MOTOROLA

Subject: Request for additional information regarding FCC ID: IHDT56GM1

Correspondence Reference Number:	IHD0509
Confirmation Number:	1608280509/510
Date of Original Email:	October 10, 2006

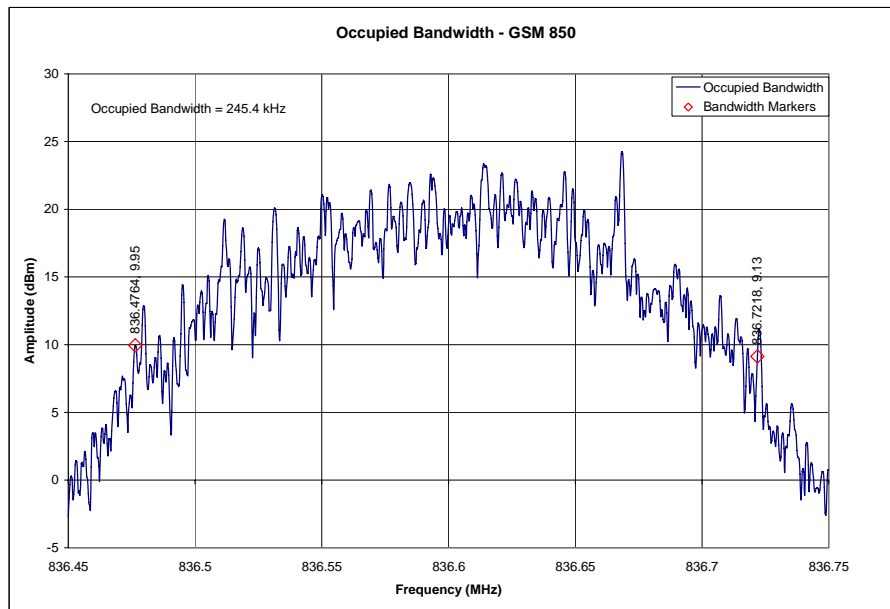
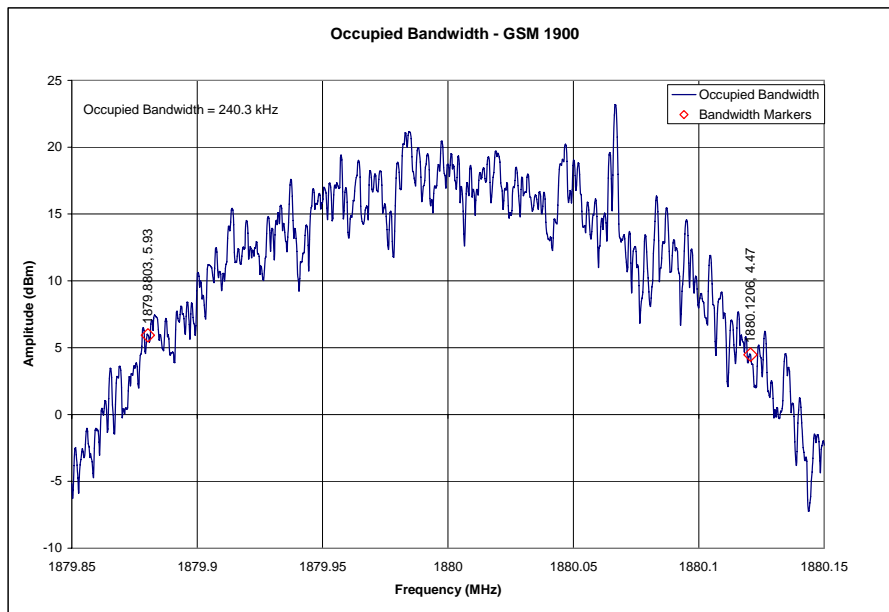
1. BW Plots on pages 9 and 11 of the EMC report are not clear.

Response: Please refer to the following plots:

Exhibit 6

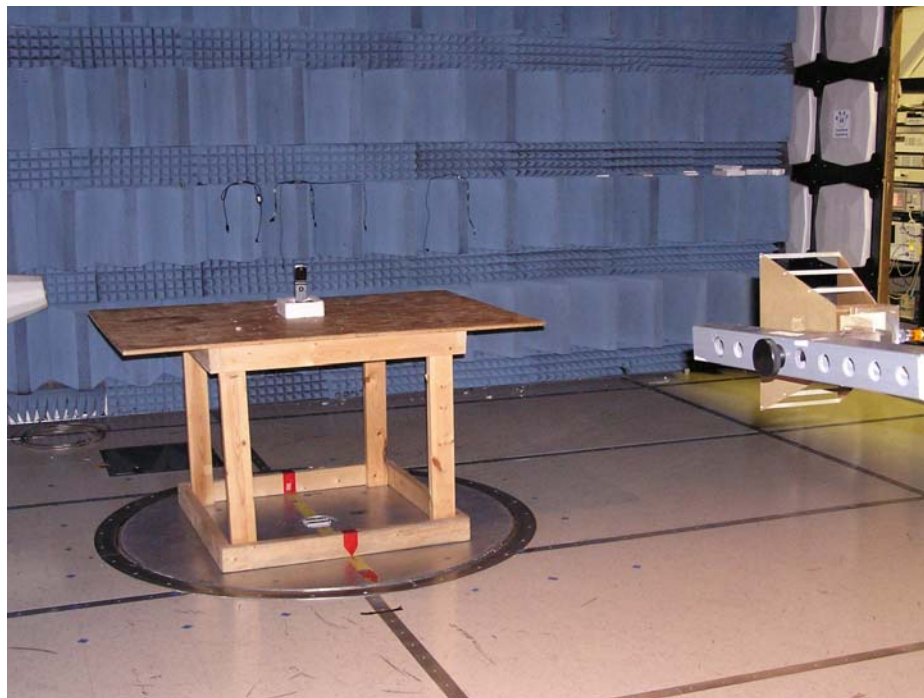
2. Please submit actual FCC Part 22/24 and Part 15B test setup photos. These photos may be held short term confidential.

Response: Please refer to the following photos:

Appendix A – Radiated Emissions Test Setup Photos

A.1 Radiated Emissions Measurement
